MAJOR REPAIR AND ALTERATION (Airframe, Powerplant, Propeller, or Appliance)

1. Aircraft	Make PIPER	Model PA-22
	Serial No. 22-1605	Nationality and Registration Mark USA N3330A
2. Owner	Name (As shown on registration certificate) JORDON, Don T.	Address (As shown on registration certificate) 7050 Shiloh Road Midlothian, Tx. 76065

FIELD APPROVAL

Fig 4

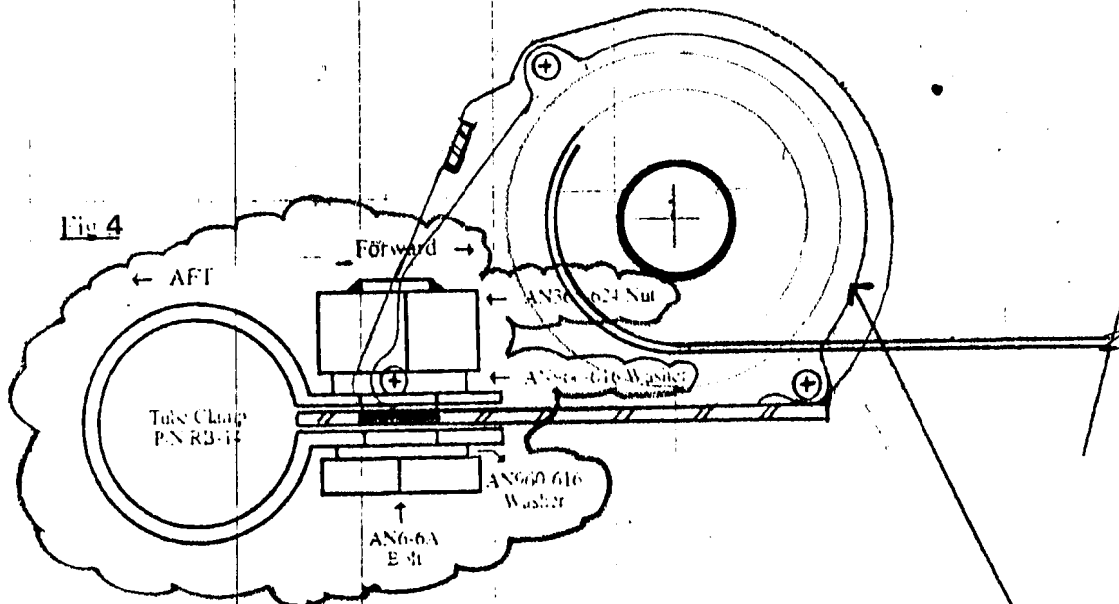
REMOVED AERO FABRICATORS INC. P/N RB-9 TRIANGULAR FITTING AND REPLACED WITH AM-SAFE P/N 501580-401 REEL
